**Re: Walnut C&DD Facility / Fairfield County**

This letter is written regarding the storm water inspection I conducted of the construction activities at Walnut C&DD, located at 8675 Lancaster-Newark Road, on September 26, 2011. I understand this site is currently covered under the General Storm Water Permit Associated with Construction Activities. Based on my site inspection and the conditions set forth in the General Permit, the following was noted:

Turbid discharge from  
Walnut Creek Watershed  
September 26, 2014  
Greg Smith

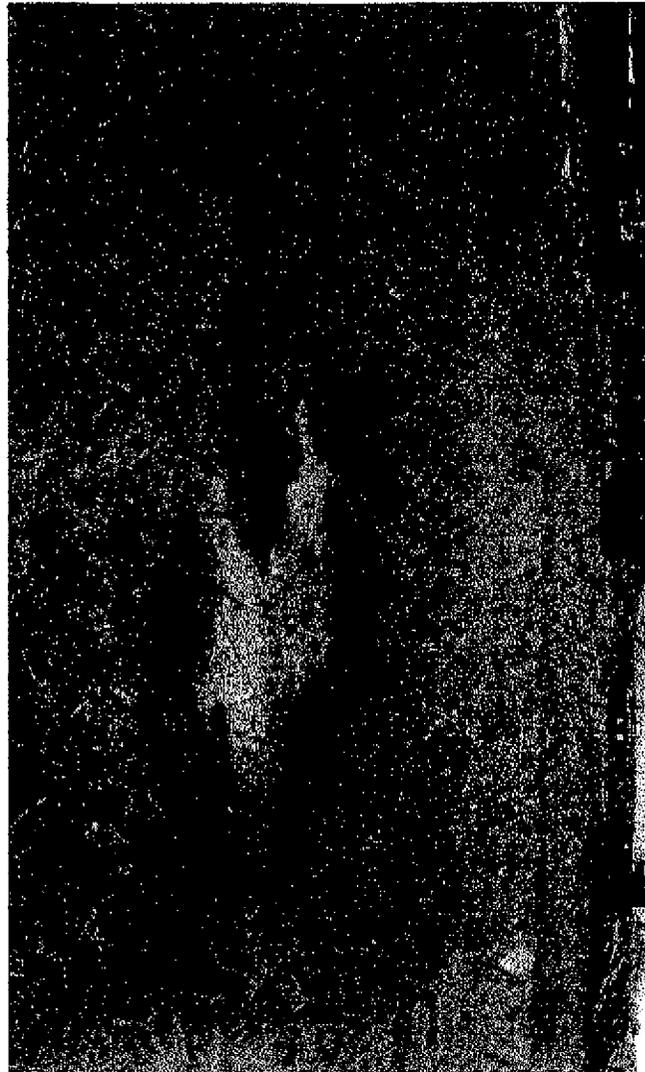
The site was mostly stabilized, however there was a small turbid discharge that was leaving the site at the front entrance. It was noted that the existing check dams consisting of silt fence and straw bales needed to be maintained. Additional controls may need to be installed to prevent the turbid discharge. Please see attached pictures.
